SWIVEL MOUNT

PCN #: 122436

Notice Type: Two new holes on the Swivel Mount

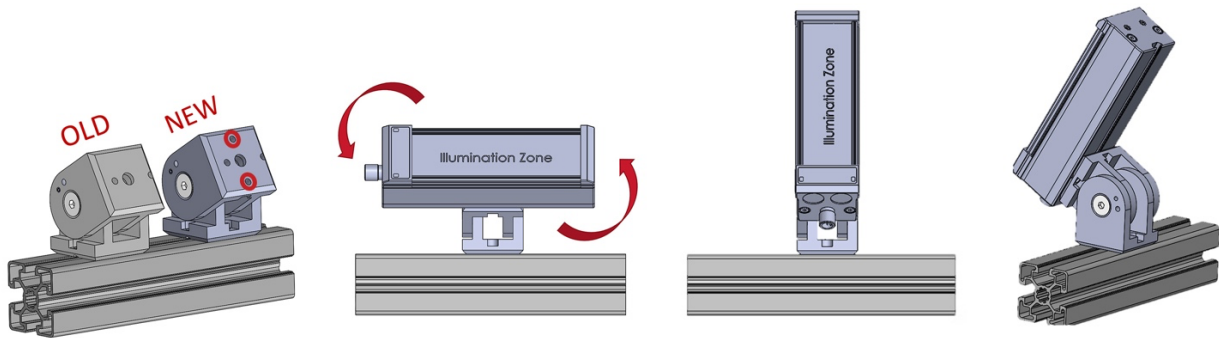
The Following Changes Are Made: Two additional holes have been added to enable the user to mount the EBAR perpendicular to the original orientation. With the old version, the EBAR can only be mounted in one direction. With the new one, you can still mount it in the old orientation but also rotate the EBAR 90°.
